# Development Management Sub Committee

**Wednesday 18 December 2019**

**Application for Planning Permission 18/09878/FUL  
at Land at East Market Street Edinburgh.  
Redevelopment and conversion of existing arches and  
change of use to provide sui generis distillery with Class 11  
(assembly and leisure) visitor centre, Class 1 (retail), Class  
3 (food and drink) and sui generis bar/tasting rooms with  
associated works including landscaping, public realm and  
means of access. (As Amended).**

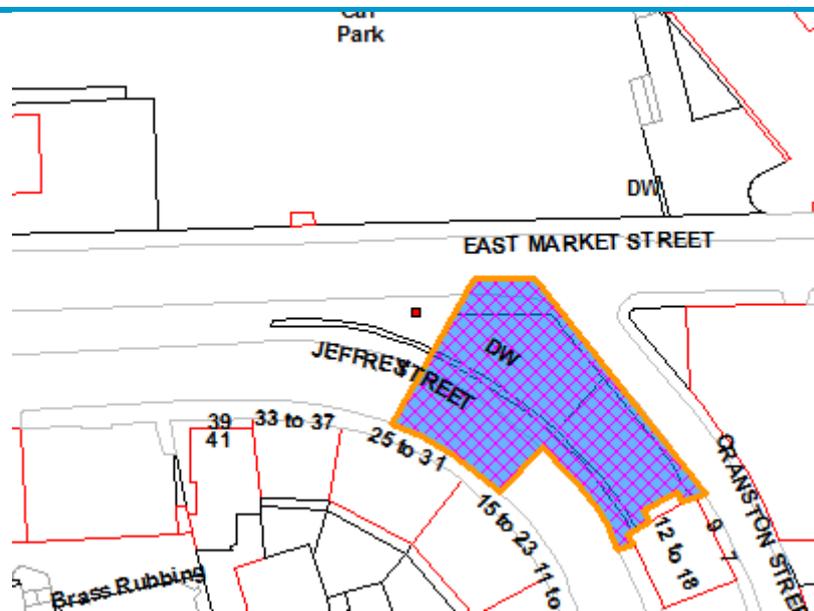
*No objections to the application subject to the following being included as conditions or informatives, as appropriate:*

- 1. Contribute the sum of £2,000 to progress a suitable order to redetermine sections of carriageway on East Market Street as loading bay as necessary for the development. The applicant should be aware that traffic order application requires a contribution sum of £2,000 to progress a suitable order to redetermine sections of carriageway as necessary for the development and its approval cannot be guaranteed;*

- 2. The radius of East Market Street/Cranston Street junction will be tightened to promote slower vehicular speeds. This is to be designed and built to the satisfaction and at no cost to the Council;*
